HIGHWAY WORK PROPOSAL

<u>COUNTY</u>	<u>STATE PROJECT</u>	<u>FEDERAL</u>	<u>PROJECT DESCRIPTION</u>	<u>HIGHWAY</u>
Door	4140-34-60	N/A	Egg Harbor-Fish Creek; Rainbow Ridge Rd-Bluff Ln	STH 042

Addendum No. 01
ID 4140-34-60
Revised Sheet 2
December 7, 2023

Addendum No. 01
ID 4140-34-60
Revised Sheet 11
December 7, 2023

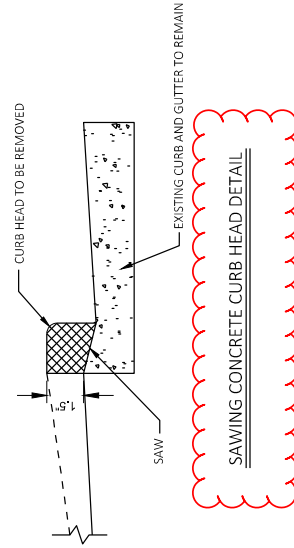
Revised Plan Sheets	
Plan Sheet	Plan Sheet Title (brief description of changes to sheet)
2	General Notes (Added note regarding driveway material types)
11	Construction Details (Revised sawing curb detail)
25	Miscellaneous Quantities (Removed 204.0150 bid item)
27	Miscellaneous Quantities (Removed 650.550 and 690.0250 bid items and added SPV.0090.01 bid item)
28	Plan Details (Added driveway material callout)
29	Plan Details (Revised driveway curb callout)
30	Plan Details (Revised driveway material callout)
52	Plan Details (Revised driveway curb callout)
